MANDATORY SERVICE BULLETIN

MSB 42-095

MSB 42NG-026

Replacement of MLG damper nut.

Drawing Number:
D60-3277-10-00_01

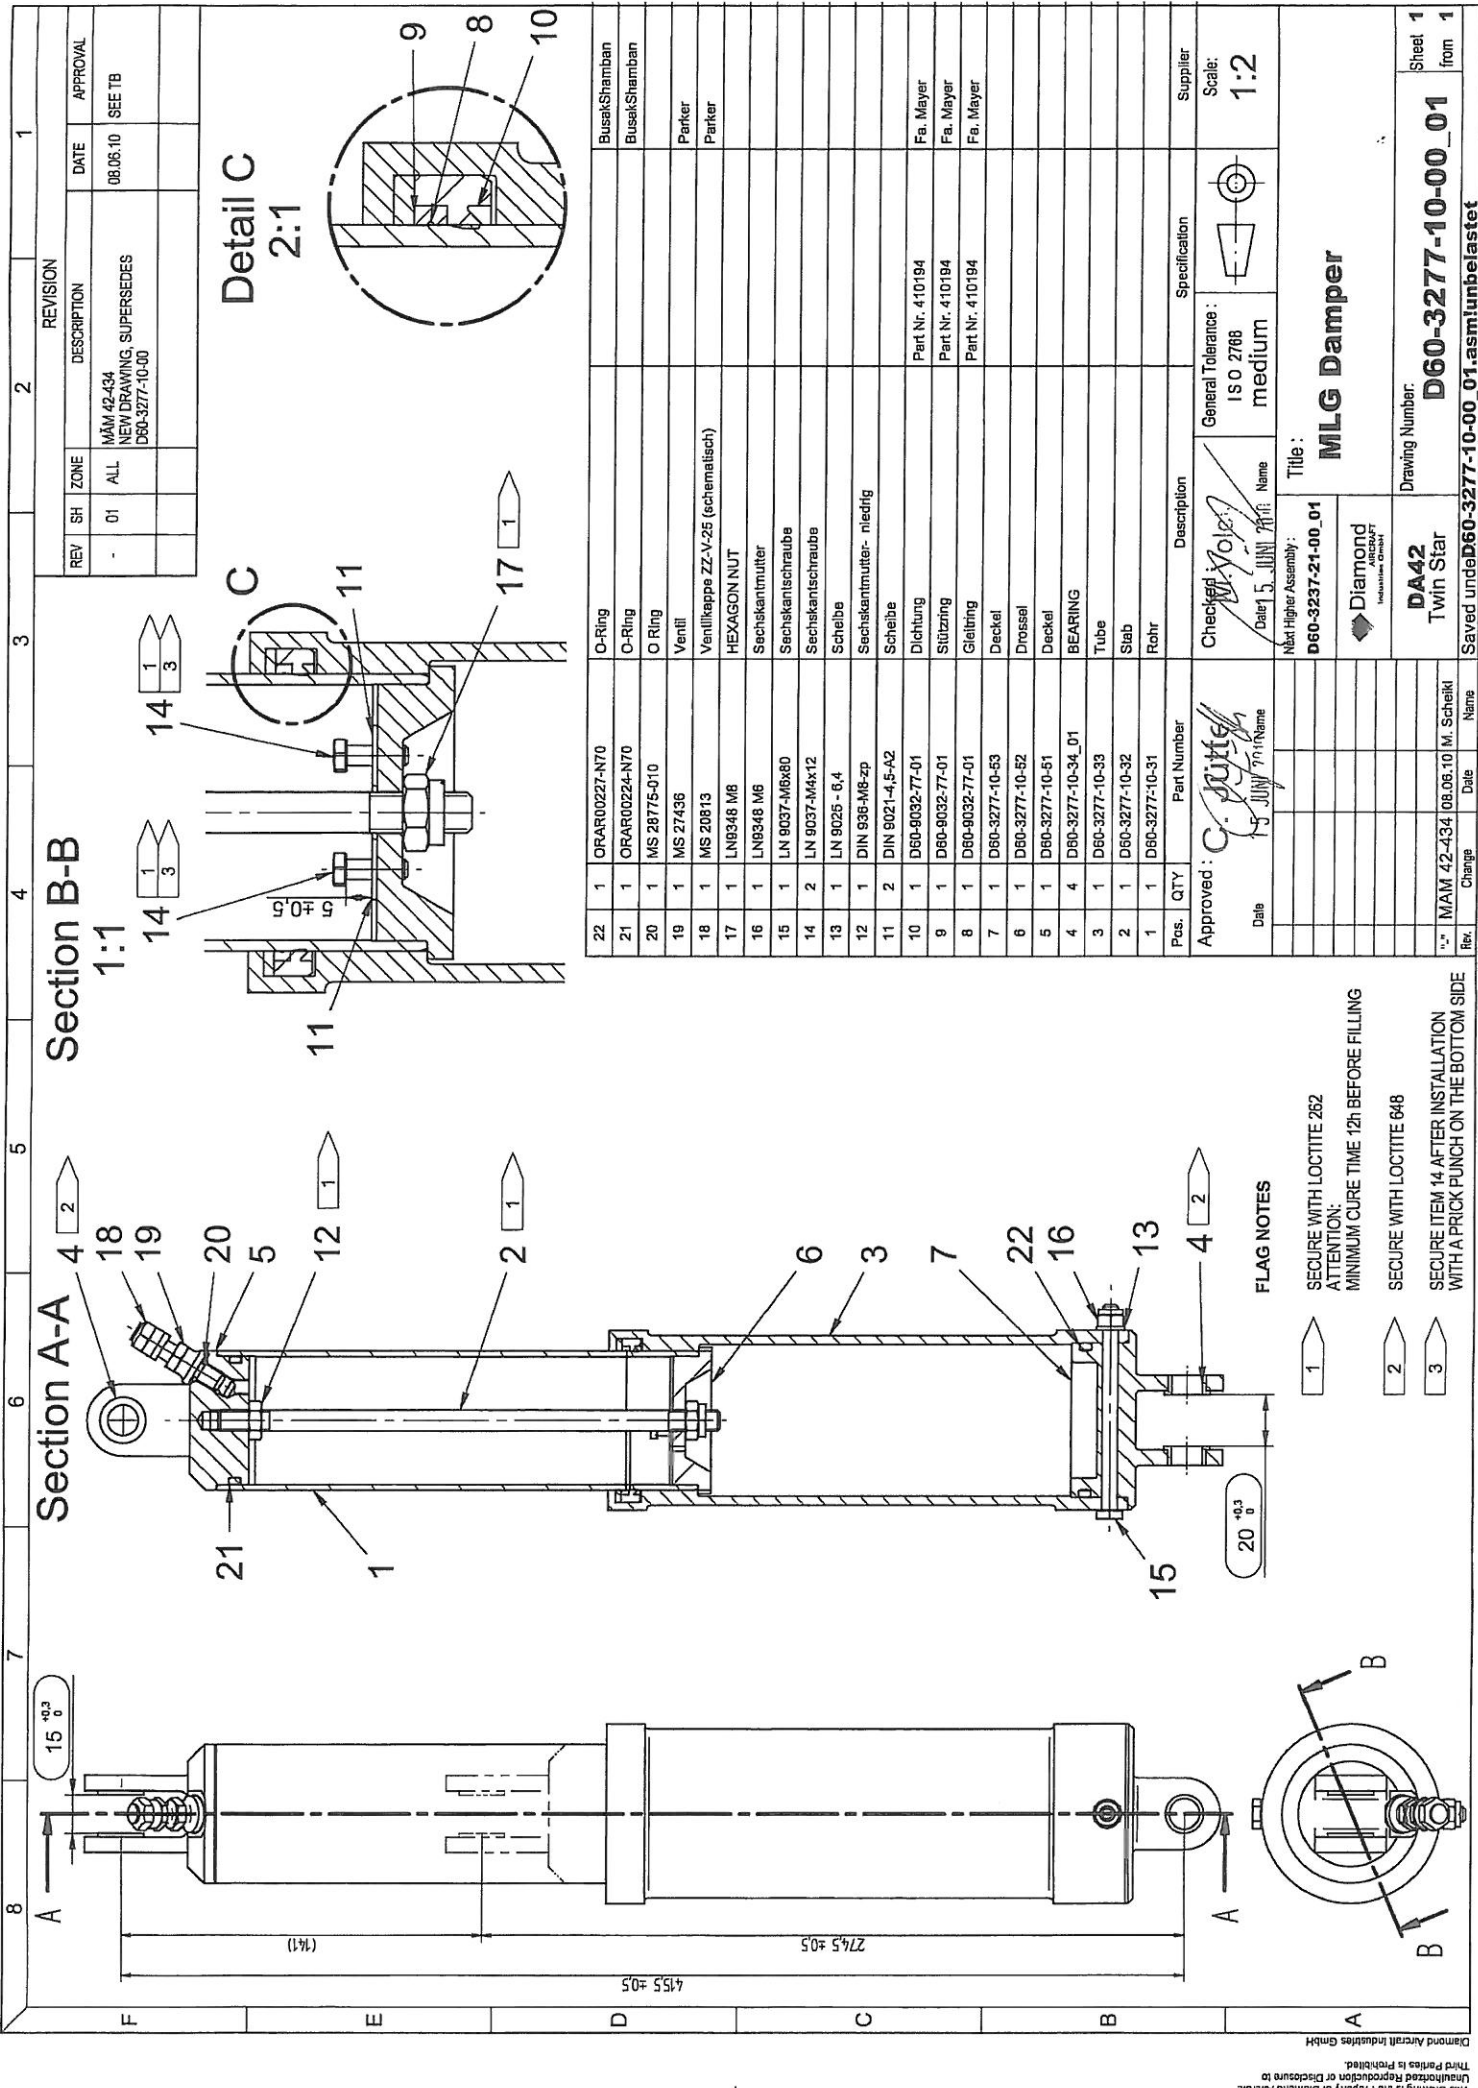
6	Remove the nut on the piston end plate.
7	<p>Install nut LN 9348-08 on the piston end plate. Secure the connection with Loctite 262 i.a.w. drawing D60-3277-10-00_01.</p>  <p style="text-align: center;">Picture 2</p>
8	Allow Loctite to cure before filling (Minimum cure time 12 hours).
9	Install the bottom cap with the bolt, washer and nut.
10	Remove the spacer from piston tube.
11	Install the charging valve with a new O-Ring MS 28775-010.
12	<p>Adjust the direction of the piston tube to the cylinder tube acc. to picture 3.</p> <p>Note: The charging valve must be aligned with the nut from the bolt holding the bottom cap.</p>  <p style="text-align: center;">Picture 3</p>
13	Fill and charge the Damper acc. to AMM Section 32-10.
14	Install the Damper to the MLG acc. to AMM Section 32-10.

REV	SH	ZONE	DESCRIPTION	DATE	APPROVAL
-	01	ALL	MAM 42-434 NEW DRAWING, SUPERSEDES D60-3277-10-00	08.06.10	SEE TB
